Access Compliance Report

Public Rights-of-Way

(Pedestrian Signals)

Intersection ID: N/A	Main Street:	Cross Street: N/A	Location: N/A
ADA ID: A5E5BD72A0BA	Signal Type: Two Push Buttons-Non APS	Overall Compliance: No	Severity Score: BTN 1:N/A BTN 2: N/A No BTN: N/A
Codes/Mitigation Info/Possible Solution		Field Measurements/Component Compliance

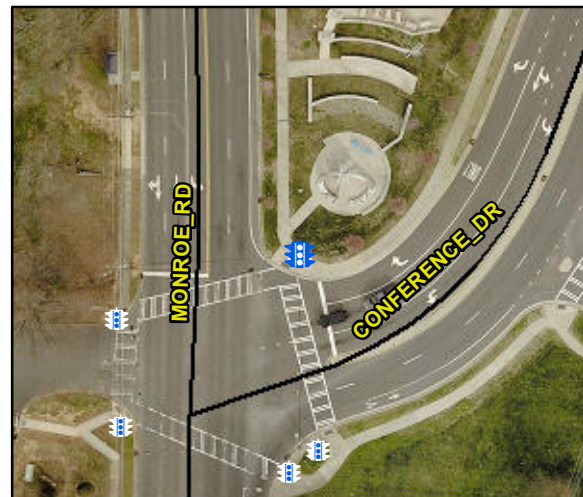
PROW/ADA: TMUTCD 4e.08, R404.2, R404.3, R406.2, R404.7.3

Compliance	Description	Data	Compliance	Description	Data
	Button Count	Button2	N/A	Distant to Additional Button (in)	N/A
	Additional Button Present?	No		Additional Button ID	N/A
N/A	Signal Buttons Required?	N/A	N/A	Additional Ped Posts Required	N/A
	How Many Ped Street Xings?	2		Located In An Island/Median?	No
N/A	B 1 Sign Present?	Yes	N/A	B 2 Sign Present?	Yes
Yes	B 1 Sign Purpose?	Yes	Yes	B 2 Sign Purpose?	Yes
Yes	B 1 Sign Lettering & Contrast?	Yes	Yes	B 2 Sign Lettering & Contrast?	Yes
Yes	B 1 Parallel To XWalk?	Yes	Yes	B 2 Parallel To XWalk?	Yes
Yes	B 1 PAR to Button?	Yes	Yes	B 2 PAR to Button?	Yes
Yes	B 1 PAR to XWalk?	Yes	Yes	B 2 PAR to XWalk?	Yes
Yes	B 1 Clear Floor Space?	Yes	Yes	B 2 Clear Floor Space?	Yes
N/A	B 1 FWD Approach?	Yes	N/A	B 2 FWD Approach?	Yes
N/A	B 1 FWD Approach Constrained?	No	N/A	B 2 FWD Approach Constrained?	No
No	B 1 FWD Approach Reach (in)	10.0	No	B 2 FWD Approach Reach (in)	13.0

N/A	B 1 FWD Approach Width (in)	N/A	N/A	B 2 FWD Approach Width (in)	N/A
N/A	B 1 FWD Approach Obstruction?	Yes	N/A	B 2 FWD Approach Obstruction?	Yes
N/A	B 1 FWD Approach Obstruction Dist (in)	6.0	N/A	B 2 FWD Approach ObstructionDist (in)	8.0
N/A	B 1 PARA Approach?	Yes	N/A	B 2 PARA Approach?	Yes
N/A	B 1 PARA Approach Constrained?	No	N/A	B 2 PARA Approach Constrained?	No
Yes	B 1 PARA Approach Reach (in)	10.0	No	B 2 PARA Approach Reach (in)	13.0
N/A	B 1 PARA Approach Width (in)	N/A	N/A	B 2 PARA Approach Width (in)	N/A
N/A	B 1 PARA Approach Obstruction?	Yes	N/A	B 2 PARA Approach Obstruction?	Yes
N/A	B 1 PARA Approach Obstruction Dist (in)	6.0	N/A	B 2 PARA Approach ObstructionDist (in)	8.0
No	B 1 Clear Floor Space Slope (%)	7.3	Yes	B 2 Clear Floor Space Slope (%)	6.1
No	B 1 Clear Floor Space XSlope (%)	2.2	No	B 2 Clear Floor Space XSlope (%)	2.5
N/A	B 1 PAR Slope (%)	6.0	N/A	B 2 PAR Slope (%)	7.8
Yes	B 1 Height (in)	42.0	Yes	B 2 Height (in)	42.0

Yes	B 1 Clear Xing Direction?	ClearlyMarked	Yes	B 2 Clear Xing Direction?	ClearlyMarked
	B 1 Crossing Direction	To SW		B 2 Crossing Direction	To SE
No	B 1 DistanceTo XWalk (in)	72.0	Yes	B 2 DistanceTo XWalk (in)	43.0
No	B 1 DistanceTo Curb (in)	128.0	No	B 2 DistanceTo Curb (in)	125.0
Yes	B 1 Diameter (in)	2.0	Yes	B 2 Diameter (in)	2.0

Possible Solutions: Replace Signal Push Button With APS Button on New Post. Remove & Relocate Sign.
